<b>DOCKETED</b>	
<b>Docket Number:</b>	09-AFC-05C
<b>Project Title:</b>	Abengoa Mojave Compliance
<b>TN #:</b>	260764
<b>Document Title:</b>	Mojave Solar Project (09-AFC-05C) Petition to Amend for OSP Shared Facilities
<b>Description:</b>	N/A
<b>Filer:</b>	Mahnaz Ghamati
<b>Organization:</b>	Abengoa Solar
<b>Submitter Role:</b>	Applicant
<b>Submission Date:</b>	12/20/2024 1:56:30 PM
<b>Docketed Date:</b>	12/20/2024

**RE: Petition to Amend the Mojave Solar Project (Docket No. 09-AFC-05): Project Modifications to Add Gen-Tie & Accommodate Construction Water Supply Serving the Proposed Overnight Solar Project**

## **PETITION TO AMEND THE DESIGN AND OPERATION OF THE MOJAVE SOLAR PROJECT TO ACCOMMODATE THE PROPOSED OVERNIGHT SOLAR PROJECT**

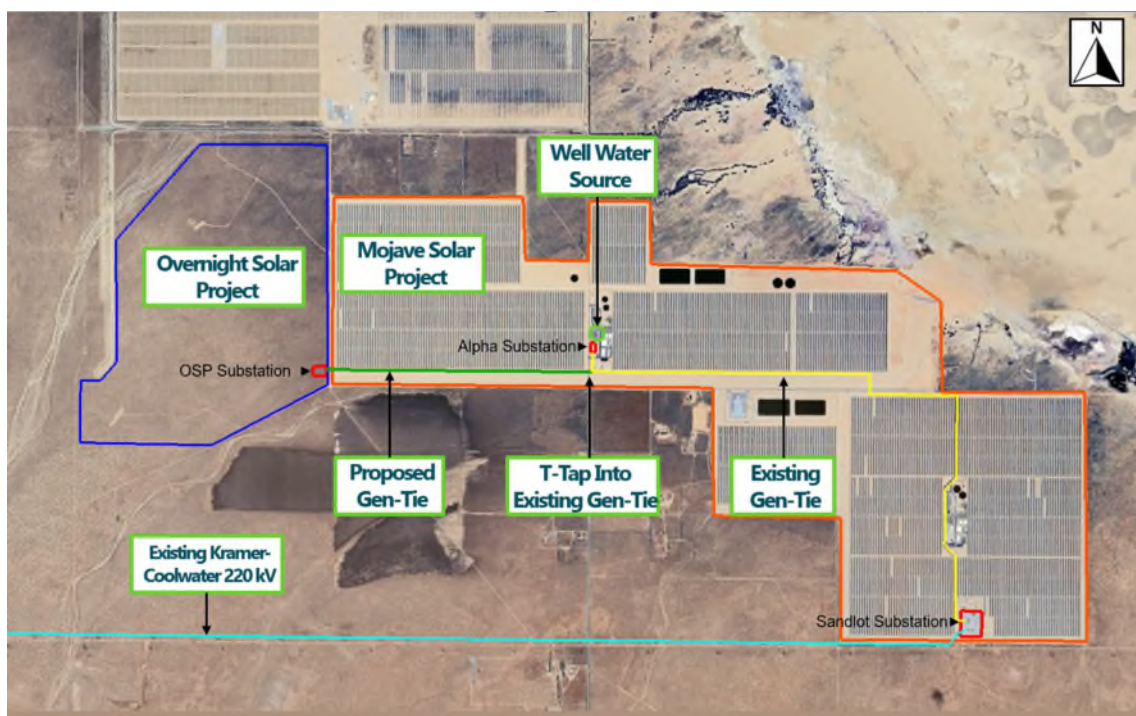
Pursuant to a Co-Tenancy and Shared Facilities Agreement between MS and OS (Agreement), MSP proposes to construct a 230 kV generation interconnect (gen-tie) corridor, approximately 1.1 miles in length that will run east across the southern portion of the MSP and connect to an existing gen-tie line located at the MSP south of the alpha substation, utilizing a t-tap. From this intertie location, MSP’s gen-tie line carries electrical power output to Southern California Edison’s (SCE) Sandlot Substation, which then interconnects to the 230 kV SCE Kramer-Coolwater Radial Line, and ultimately ties into the Kramer Junction Substation at the point of interconnection (POI). See Figure 1, below.

The current line rating for MSP's Alpha Unit is 360 MVA. MSP is utilizing only 137.5 MVA of this capacity, resulting in a 222.5 MVA surplus. The OSP will utilize up to 150 MVA of the existing unutilized transmission capacity, providing a reserve of 70 MVA after the OSP's interconnection into MSP's existing transmission facilities.

The new gen-tie poles on the MSP site will be consistent with the design and specifications of the existing transmission line on the MSP site. This means that the pole height will be up to 95 feet tall, matching the existing alpha east gen-tie poles. OS is obtaining a height variance for the new gen-tie poles from the County. Approximately 11 new poles will be needed for the new gen-tie. The gen-tie corridor would temporarily be 120 feet wide during construction and would ultimately be 80 feet wide once operational. The gen-tie poles would also carry the telecommunication lines for the Project and tie into the existing telecommunication lines at the proposed t-tap location.
